AMENDMENT NO. 84 TO FACILITY OPERATING LICENSE NO. DPR-32

AMENDMENT NO. 85 TO FACILITY OPERATING LICENSE NO. DPR-37

SAFETY EVALUATION BY THE OFFICE OF NUCLEAR REACTOR REGULATION  
RELATED TO AMENDMENT NO. 84 TO FACILITY OPERATING LICENSE NO. DPR-32  
AND AMENDMENT NO. 85 TO FACILITY OPERATING LICENSE NO. DPR-37

VIRGINIA ELECTRIC AND POWER COMPANY  
SURRY POWER STATION, UNIT NOS. 1 AND 2  
DOCKET NOS. 50-280 AND 50-281

FIGURE 5.4-1

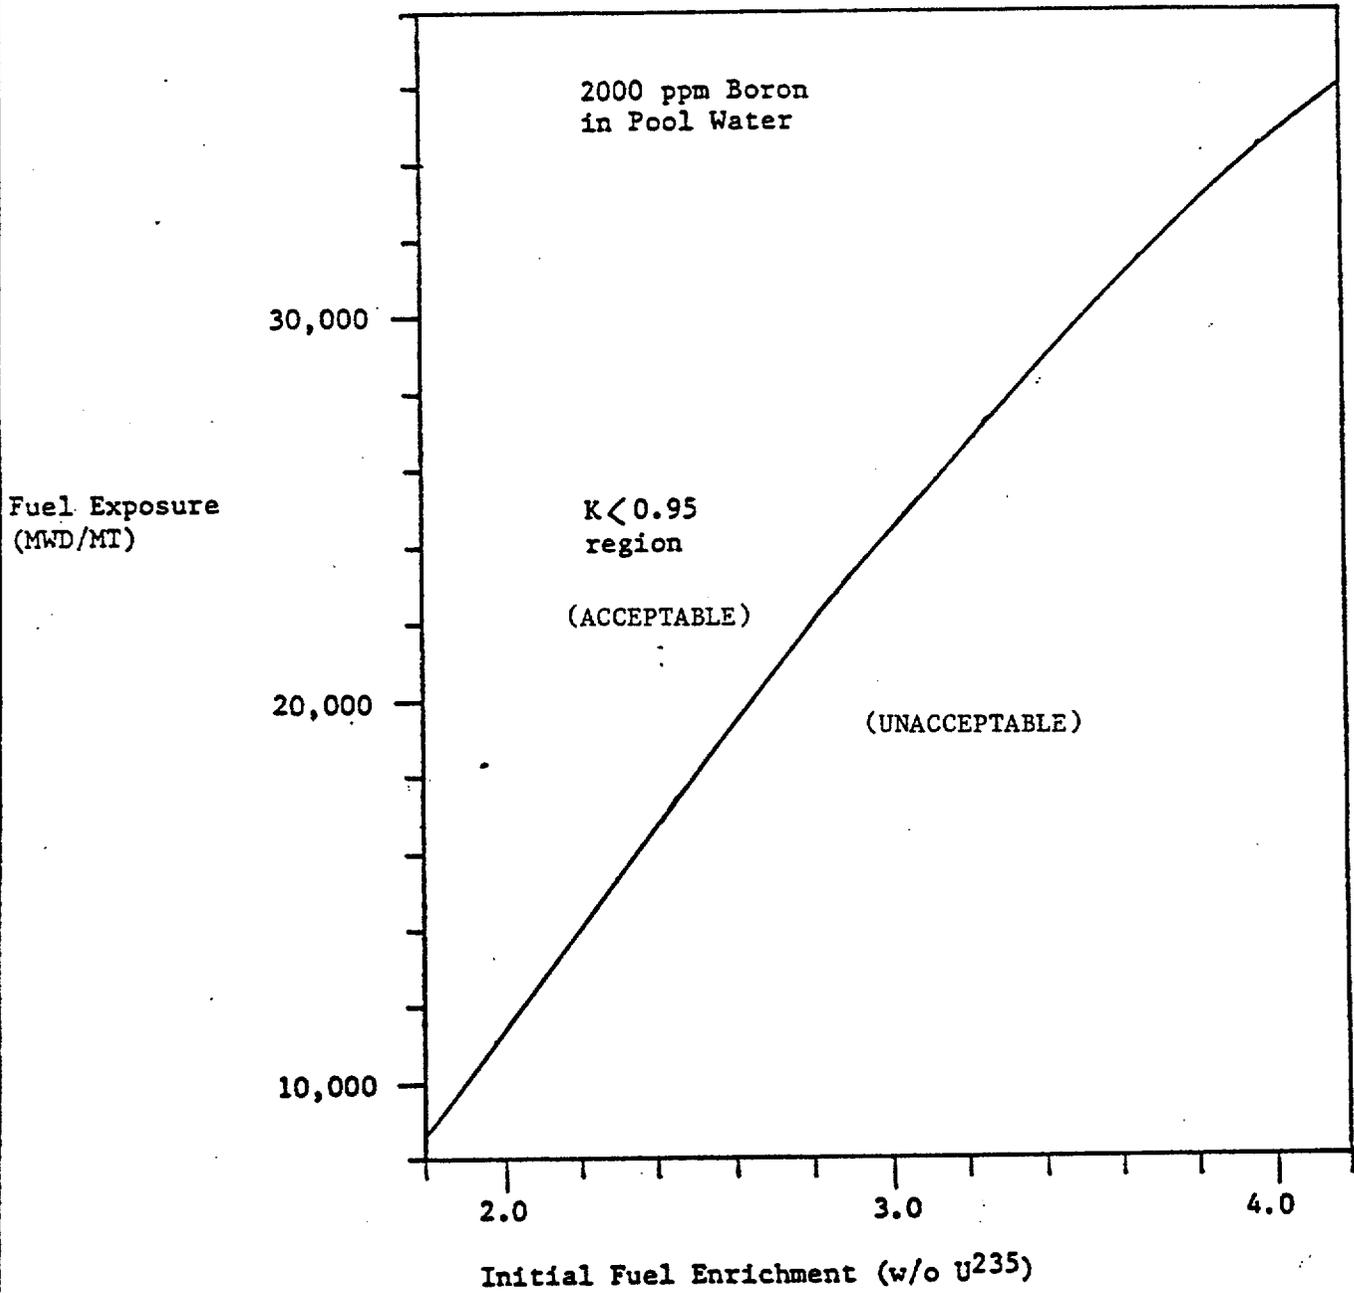
| <u>Remove Pages</u> | <u>Insert Pages</u> |
|---------------------|---------------------|
| -----               | Figure 5.4-1        |

assemblies to assure  $k_{\text{eff}}$  0.95, even if unborated water were used to fill the spent fuel storage pit. The spent fuel pool is divided into a two-region storage pool. Region 1 comprises the first three rows of fuel racks (324 storage locations) adjacent to the Fuel Building Trolley Load Block. Region 2 comprises the remainder of the fuel racks in the fuel pool. During spent fuel cask handling, Region 1 is limited to storage of spent fuel assemblies which have decayed at least 150 days after discharge and shall be restricted to those assemblies in the "acceptable" domain of Figure 5.4-1. Administrative controls with written procedures will be employed in the selection and placement of these assemblies. The enrichment of the fuel stored in the spent fuel racks shall not exceed 4.1% weight percent of U-235.
